COUNTRY DOCTOR

MEDICAL CLINIC & APARTMENT HOUSING
510 19TH AVENUE EAST

DESIGN REVIEW RECOMMENDATION MEETING #2 - April 12th 2017
EAST DESIGN REVIEW BOARD- DPD PROJECT # 3019411

RESPONSE TO BOARD

DEPARTURE REQUEST 2:

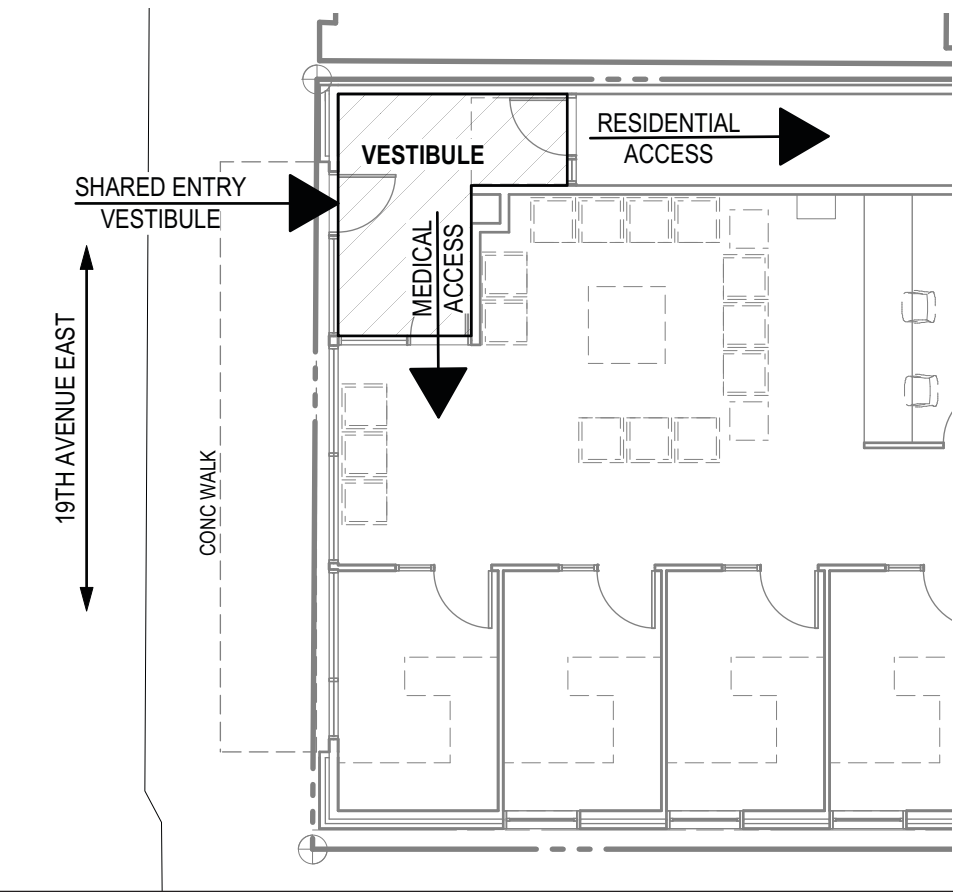
Shared entry vestibule for housing and medical clinic
SMC 23.47A.008.D:1 STREET LEVEL DEVELOPMENT STANDARDS: Where residential uses are located along a street-level street-facing facade the following requirements apply At least one of the street-level street-facing facades containing a residential use shall have a visually prominent pedestrian entry.

Due to the narrow street frontage (39') and the code requirement to provide a vestibule for the building we are requesting using a shared vestibule for the medical clinic and housing,in order to provide more glazing into the clinic waiting area which enhances Street-Level Transparency (PL2-B-3) and stronger connection to the street (CS2-B-2)

DEPARTURE REQUEST 1:

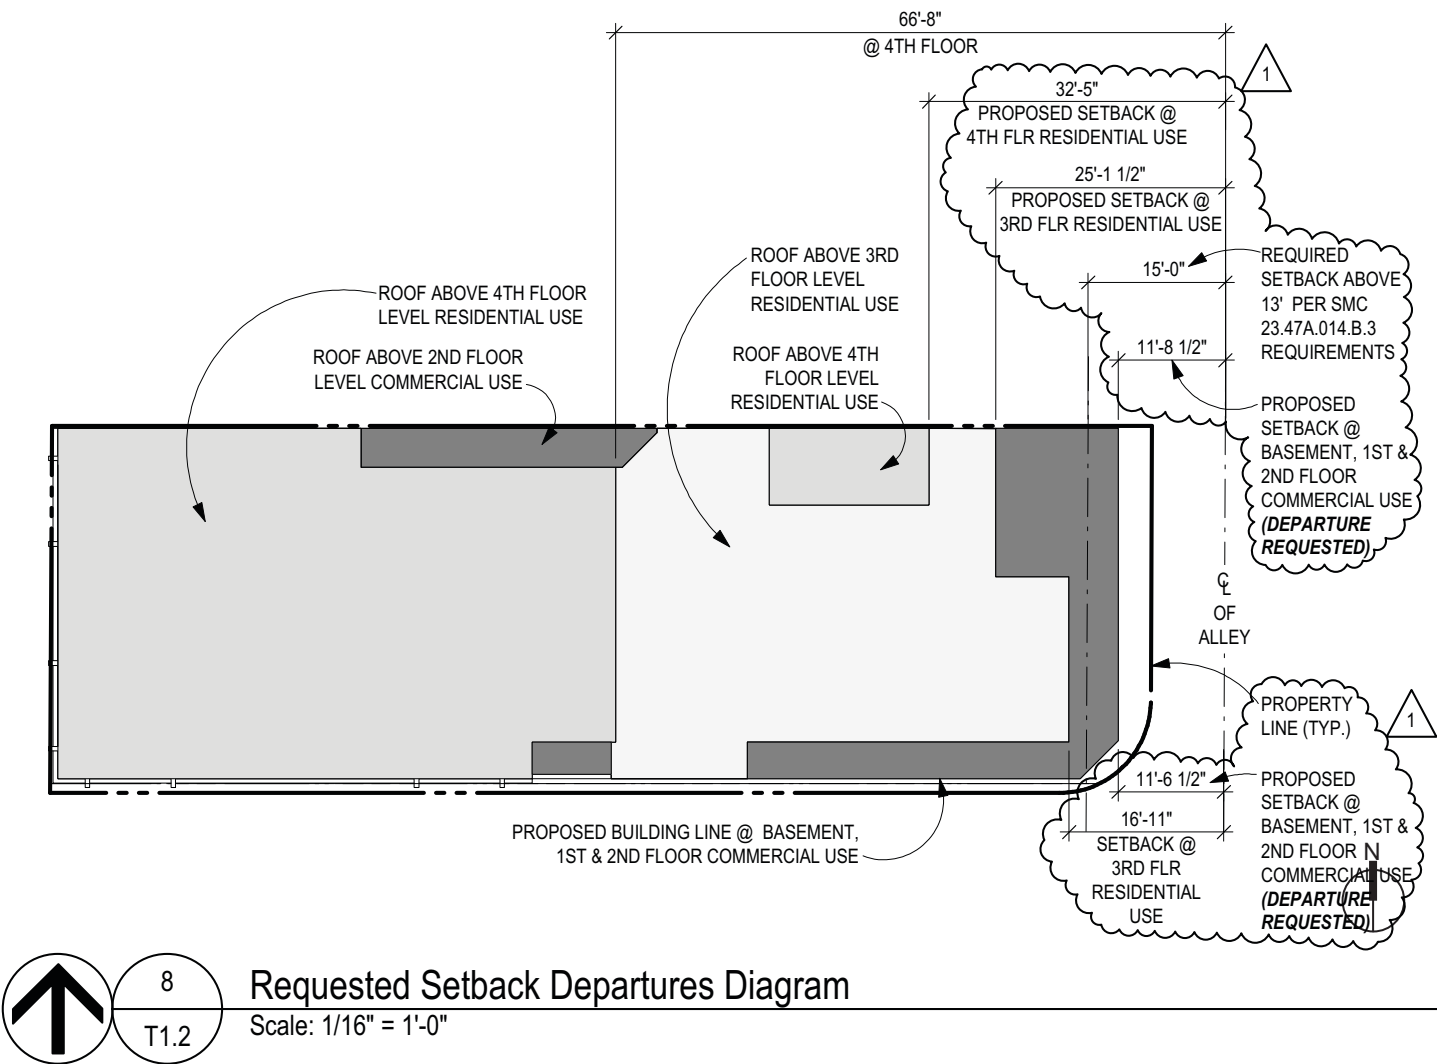
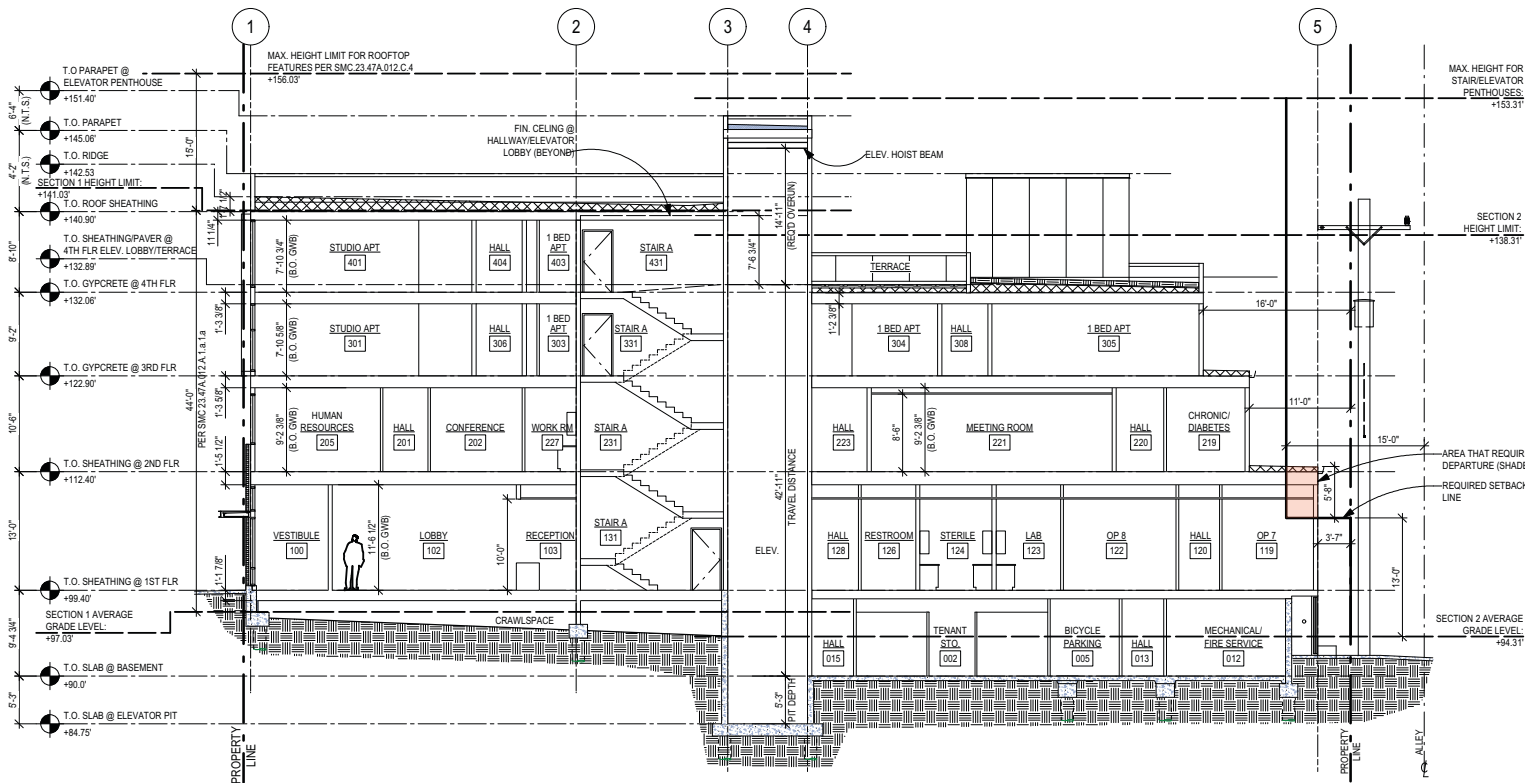
PER THE EDG MEETING: "The Board indicated preliminary support for the departure request (a reduction of the upper level setback to 10-feet) subject to further analysis the project's ability to contribute to the existing lively character of the alley space. (CS2-B, PL1-A, DC1-C)"

Alley facade will be planted with a green wall along its entire east alley frontage to provide an enhanced pedestrian experience for those walking down the alley (PL1-A-1). The 11'-6" setback follows the wall line of the building to the north (Capitol Court Apts.) to help create a strong connection to Adjacent Sites (CS2-B-2). We are proposing a 11'-6" setback from the centerline of the alley for the basement level (which is 3'6" more that the 0' setback from the property line allowed by the land use code) and artisan designed ornamental steel doors into the solid waste and medical gas enclosure to reduce their visual impact (DC1-C-4). The 3rd floor residential floor is setback 16'9" from the centerline of the alley (more than the 15' setback required by the land use code) to further reduce the impact of the building to the neighbors to the east (CS1-B-2).
